LiDAR Quality Assurance (QA) Report
Eastern Shore Virginia (ESVA) LiDAR Project
USGS
November 18, 2011

Submitted to:
USGS

Contract:
G10PC00013

Prepared by:
 **Dewberry**

Figure 21-Tile S23_3930_10, Delivery 1. Delineation of water body did not correctly follow shoreline, leaving a large area of the feature missing.

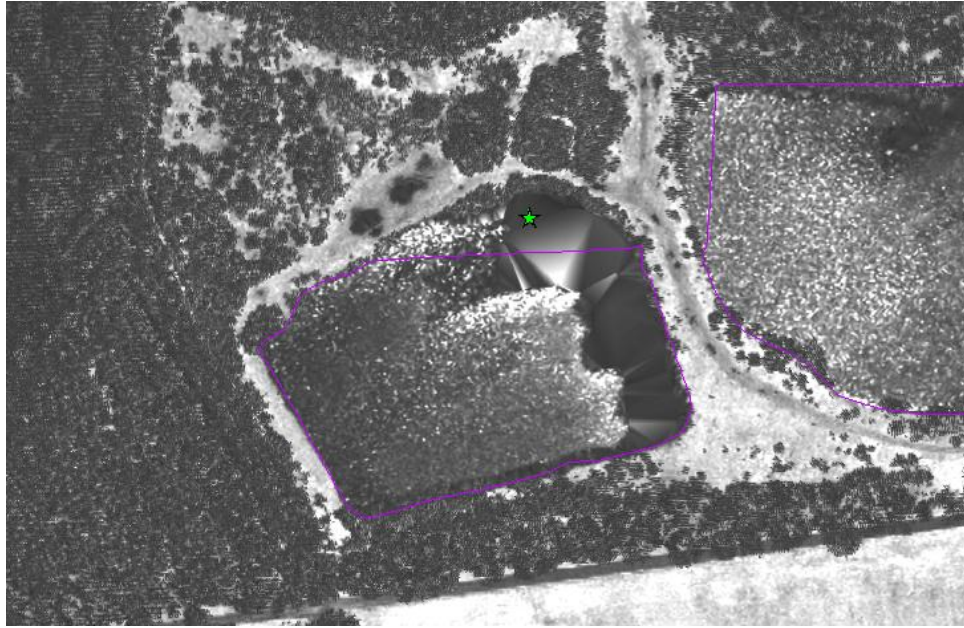
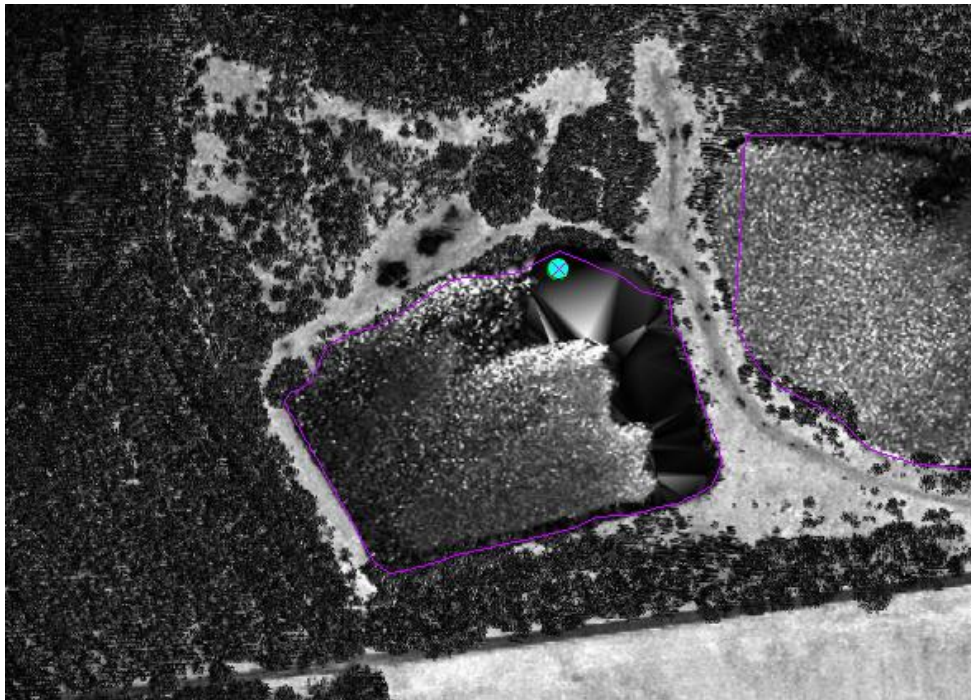
The delineation of features (104) in some areas was identified in the first delivery as not correctly following the shoreline. These features were updated in subsequent deliveries to better reflect the land/water interface at the time of LiDAR collection. An example is shown below.

Figure 22-Tile S23_3930_10, Delivery 4. Delineation of water body has been corrected to fully capture feature.

Figure 23-Tile S23_3858_10, Delivery 1. Unnatural appearance of Inland Stream, shown with blue line. Feature should have been rounded off where it becomes too narrow to meet specifications, so as not to appear to be “cut-off”, or stopped by a man-made structure.

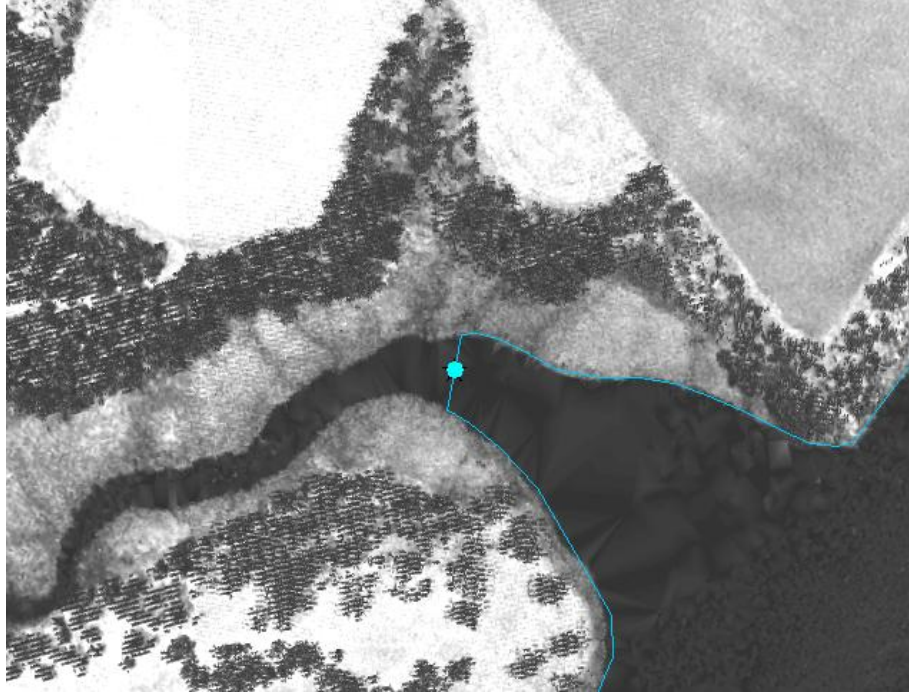
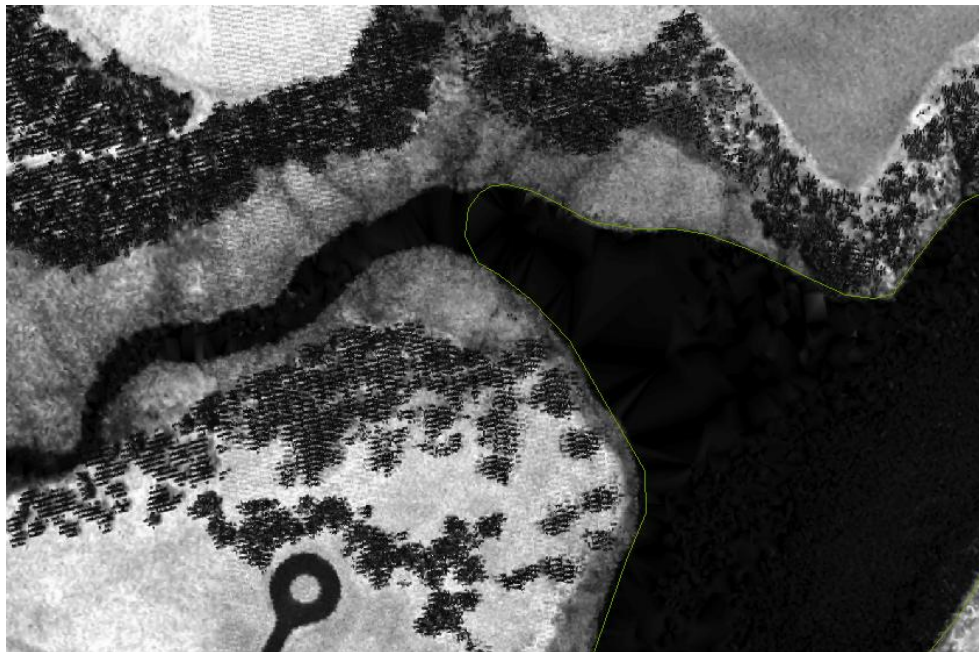
During the first review it was noted that when some features became too small to meet minimum collection requirements, the breaklines (7) were abruptly stopped or appeared “cut off” as if a man-made structure was at that location. These breaklines were corrected to appear more natural and not mistaken for man-made features, such as dams. An example is shown below.

Figure 24-Tile S23_3858_10, Delivery 4. Unnatural appearance of Inland Stream, shown with green line, has been corrected by rounding it off. This feature no longer appears to be “cut-off”, or stopped by a man-made structure.

Figure 25-Tile S23_3845_40, Delivery 1. The incorrect horizontal placement of this feature along the bank was causing sections of it to be digging by several feet. Breaklines need to be adjusted to define the actual land/water interface.

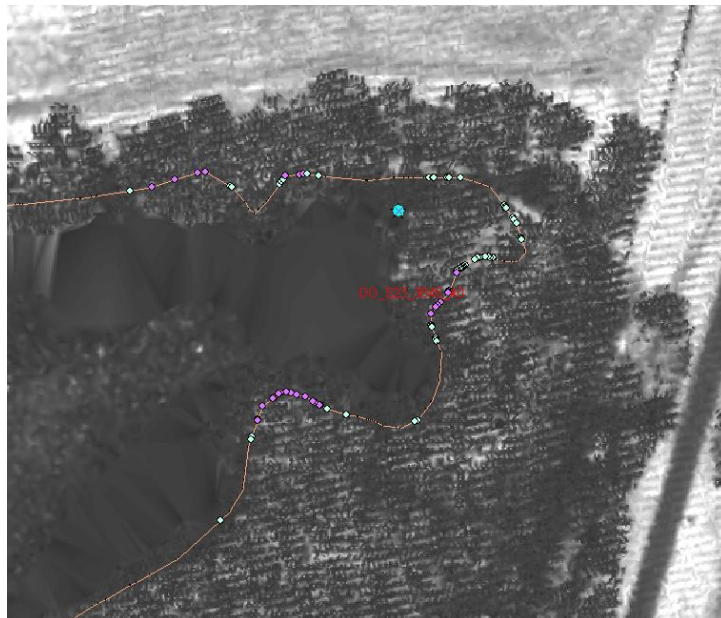
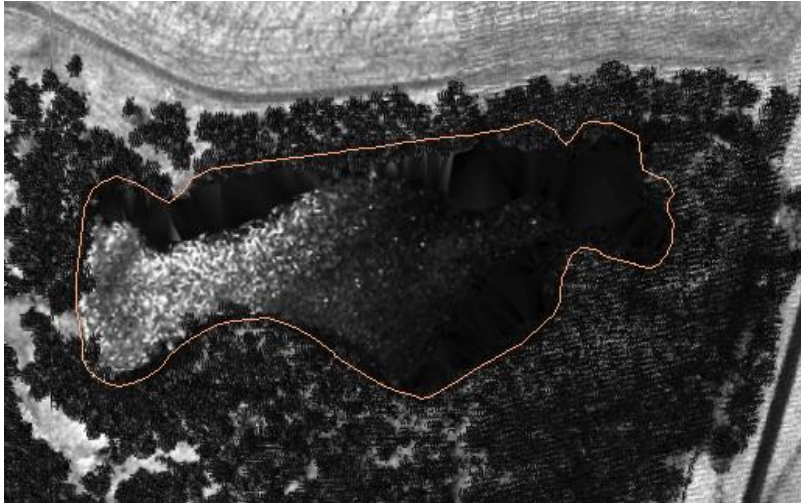
Per USGS specification, all breaklines must be at or just below the surface of the surrounding terrain. To ensure this requirement is met, the ΔZ is reviewed for every vertex. Vertices floating above the surrounding terrain by more than 0.1ft are considered an error as 0.1ft is noticeable in the DEMs. Vertices digging by more than 1ft were also reviewed. Vertices digging due to LiDAR noise, holding pond and lake elevations constant, etc. are not considered to be errors. A few edit calls (23) were placed during the first review for water body features that were digging by several feet due to incorrect horizontal placement. Sanborn corrected these issues in subsequent deliveries by modifying the breaklines to show the actual land/water interface. Elevations for features that were identified as floating (2) or excessively digging (3) in the first review was corrected in subsequent deliveries.

Figure 26-Tile S23_3845_40, Delivery 4. The horizontal placement of this feature was corrected to show the actual land/water interface.

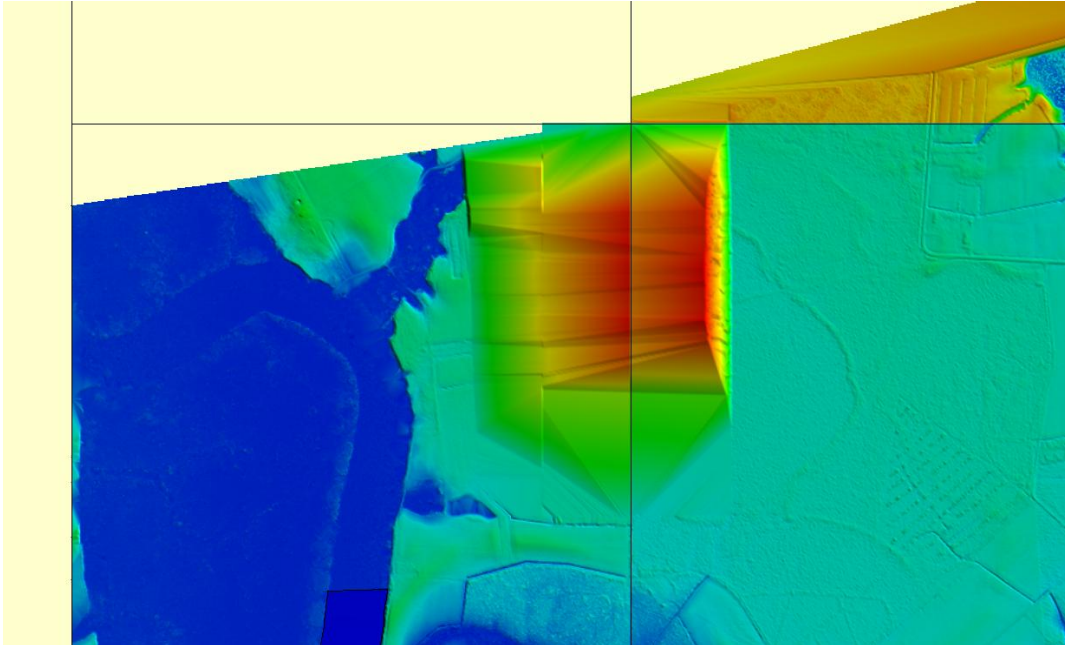
The DEMs have coverage to the full extent of the project boundary. Data was not clipped to this boundary, but extends well beyond the boundary. Data extending beyond the boundary may not always have full coverage and DEMs may not be flattened in these areas outside of the boundary. Some of this data outside of the boundary may have coverage gaps and be unusable. Sanborn is not required to clip the data. EROS has elected to receive all data and to perform the final clipping so that they control the final clipping boundary and selection of data that will ultimately be used in the NED program. An example of unusable data located outside of the project boundary is shown below.

Figure 27-DEM_S23_3910_10, all deliveries. Some areas outside of the project boundary may be unusable. The identified area is a coverage gap well outside of the required project boundary, with an anomalous high ridge along the eastern side of the gap. This particular area is unusable even though it was delivered with the final DEMs. EROS will perform the final clipping of the data.

Figure 28-DEM_S23_2652_20, Delivery 1. Multiple artifacts with varying elevations were located within Tidal Waters.

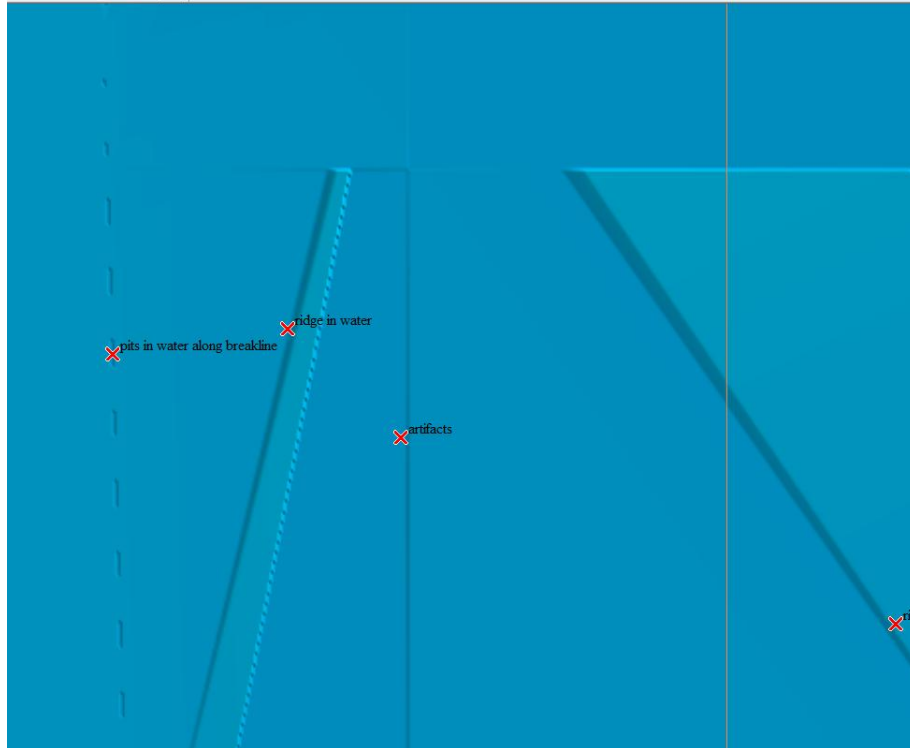
Numerous artifacts (315) were identified within water features in the first delivery. Sanborn modified their production process and the DEMs are now flat from bank to bank. Examples are shown below.

Figure 29-DEM_S23_2652_20, Delivery 4. The only elevation change in the water of this tile occurs along the flight line from tidal variations. This step is an acceptable way to show elevation change in water. The water is flat from bank to bank.

Figure 31-DEM_S23_2759_20 and DEM_S23_2759_30, Delivery 4. Now, the only elevation change in the water of these tiles occur along the flight line from tidal variations. This step is an acceptable way to show elevation change in water. The water is flat from bank to bank.

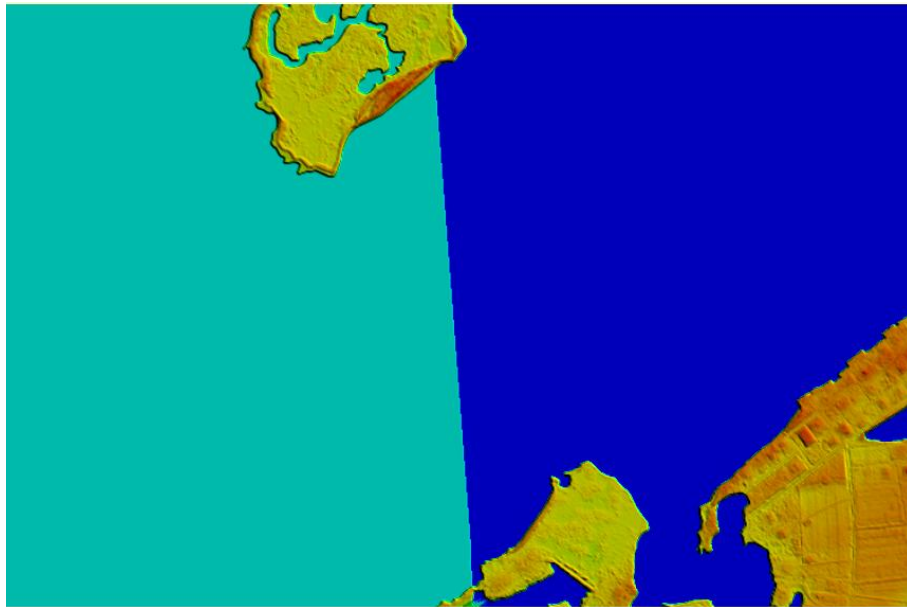
Figure 30-DEM_S23_2759_20 and DEM_S23_2759_30, Delivery 1. Multiple artifacts with varying elevations were located within Tidal Waters.

Figure 32-DEM_S23_3829_10, delivery 1. Tidal waters were floating above the surrounding terrain.

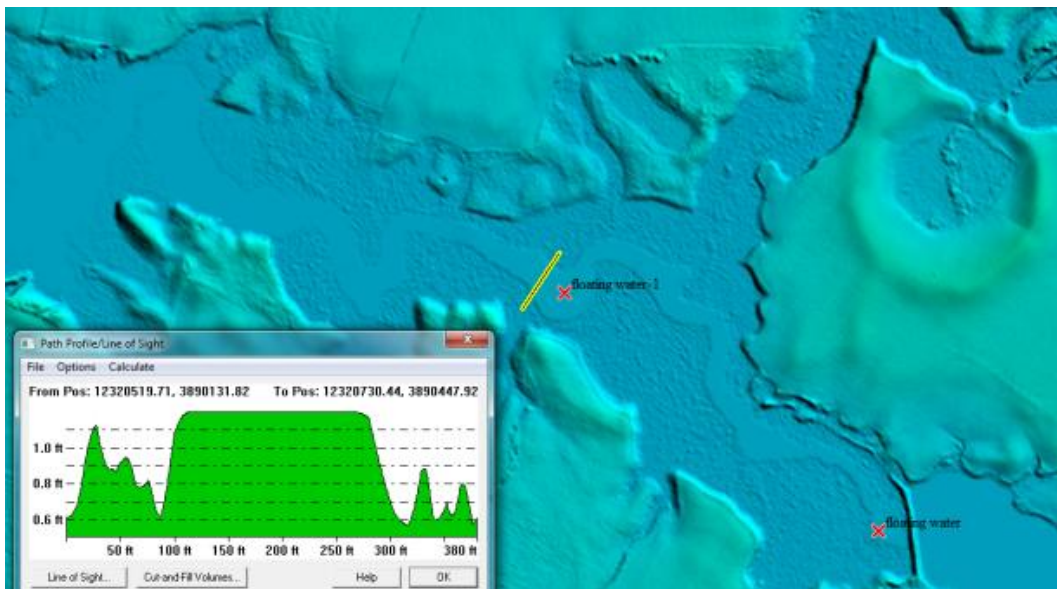
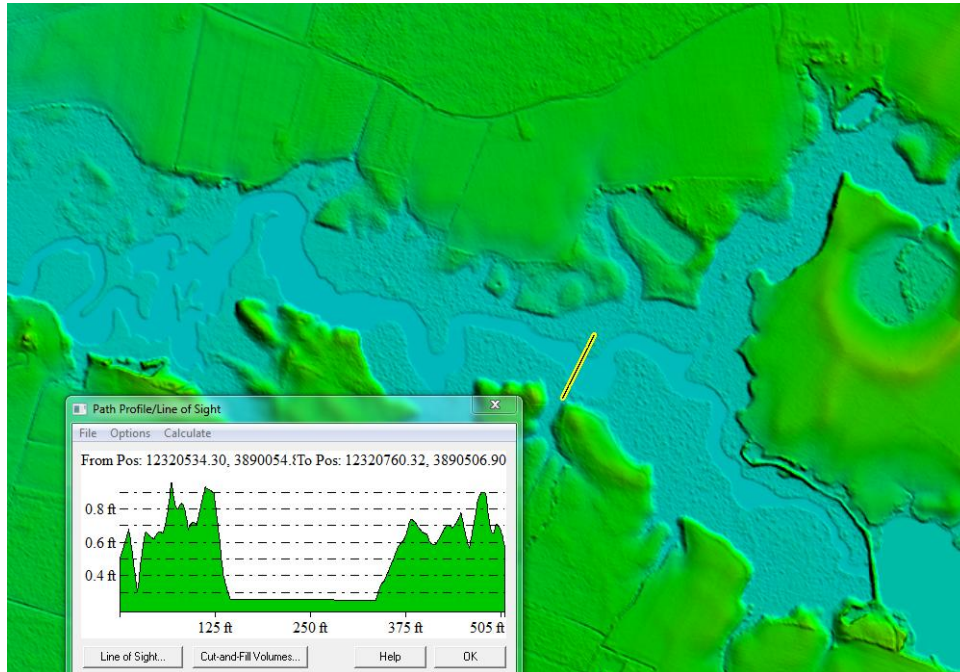
A few features (9) were identified in the first delivery as floating in the DEMs. These features were adjusted to be at or below the surrounding terrain. An example of the corrections is shown below.

Figure 33-DEM_S23_3829_10, delivery 4. Tidal waters that were floating above the surrounding terrain have been corrected and are now at or below the surrounding terrain.

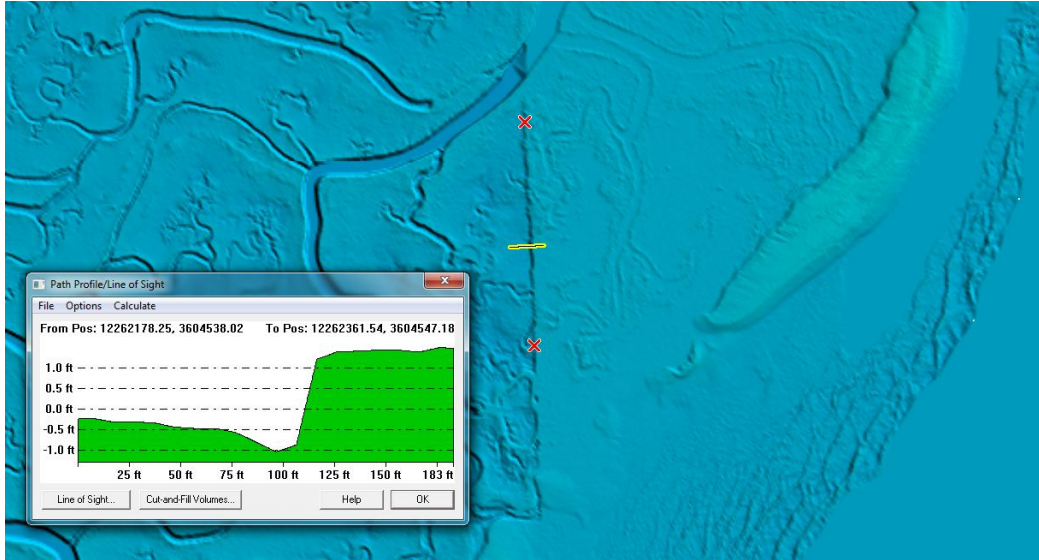
Numerous edit calls (23) were placed in the first delivery where flight line ridges between two adjoining swaths exceeded 12 cm or 0.4 ft as outlined in the Quality Plan. These issues were corrected when Sanborn re-calibrated the LiDAR data. A few flight line ridges were identified in previous deliveries. Most of these were corrected when Sanborn re-calibrated the LiDAR data. However, varying water levels in marsh or vegetated areas can affect the return of LiDAR signals to the sensor. Some LiDAR signals may show a greater absorption in wetter marsh areas compared to drier marsh areas. This greater absorption before the LiDAR signal is transmitted back to the sensor can translate into lower elevations. Or, some LiDAR signals may reflect off of the thin water layer covering or partially covering an island rather than reflecting off of the “ground” surface. The LiDAR could potentially show different responses between adjoining flight lines in marsh or wet areas such as tidally exposed islands, depending on the tide levels. Some of this variance in the LiDAR return signals may result in an elevation step between adjacent flight lines. These flight line ridges that occur in marsh like land cover types were not held to the USGS 10 cm relative accuracy specification for adjoining swaths as the flight line ridges do not occur over “true” ground. An example of flight line ridges that may still appear in the dataset is shown below.

Figure 34-DEM_S23_2660_20 and DEM_S23_2660_10, All deliveries. Flight line ridges are more prominent on tidally exposed ground. These tidal flats can be very marshy with varying levels of water present. As these areas are not “true” ground, they were not held to the same relative accuracy specifications outlined for actual ground.
